HOT OIL PIPE DIAGRAM
 NOT TO SCALE

DATE	REVISION	BY
NOV 11 11	VALUE ENGINEERING RE-DESIGN DOCUMENT

PROJECT NO. 8529-02
 DESIGNED BY RCD
 DRAWN BY TBW
 CHECKED BY RCD
 REVIEWED BY
 DATE JULY 2011
 SCALE 1/8" = 1'-0"

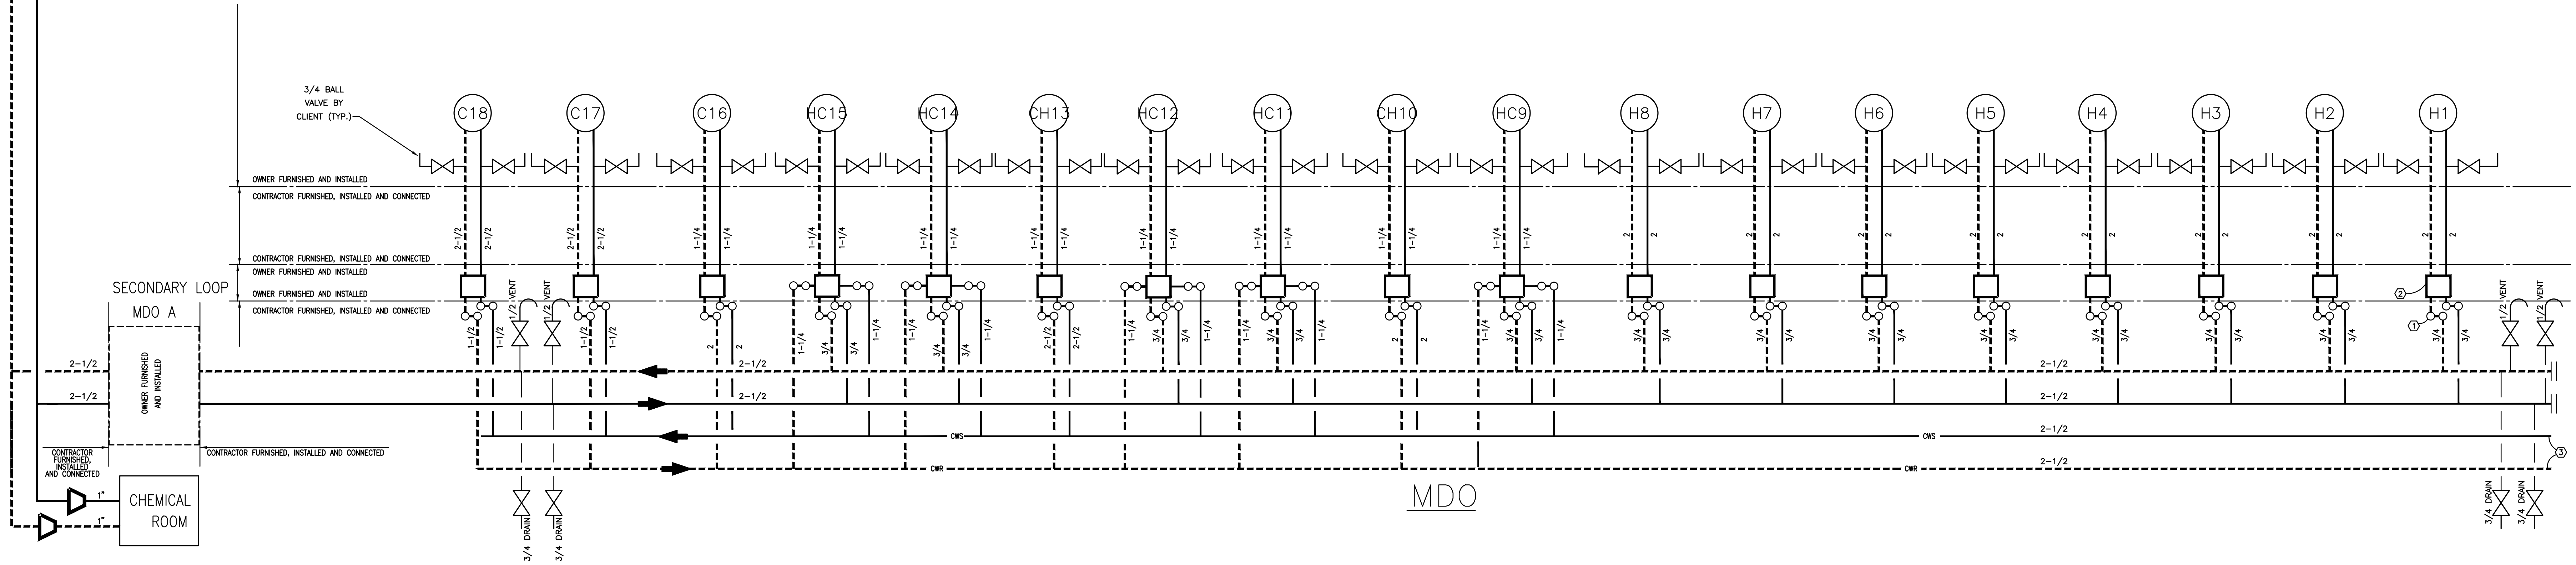
NOTES: SOME CONTROL IS REQUIRED FROM TFH PANEL TO CONNECT THESE WITH PROCESS COMPUTER. CABLE FROM EACH EQUIPMENT FOR AND INPUT/OUTPUT SIGNAL WILL GO TO CONTROL PANELS (6 H1) WHICH WILL BE LOCATED IN CONTROL PANEL ROOM (P-125).

1. FAULT STATUS CONTACT FROM HEATER PANEL IS REQUIRED. THIS IS REQUIRED TO KNOW THE STATUS OF TFH ON PROCESS COMPUTER.
2. HOT OIL TEMP. REFERENCE (4-20 MILLIAMPS) IS REQUIRED TO CONTROL PANEL 6H-1. THIS CAN BE GIVEN FROM THE TEMPERATURE CONTROLLER OF HEATER CONTROL PANEL. THIS IS REQUIRED TO READ THE HOT OIL TEMPERATURE ON PROCESS COMPUTER.
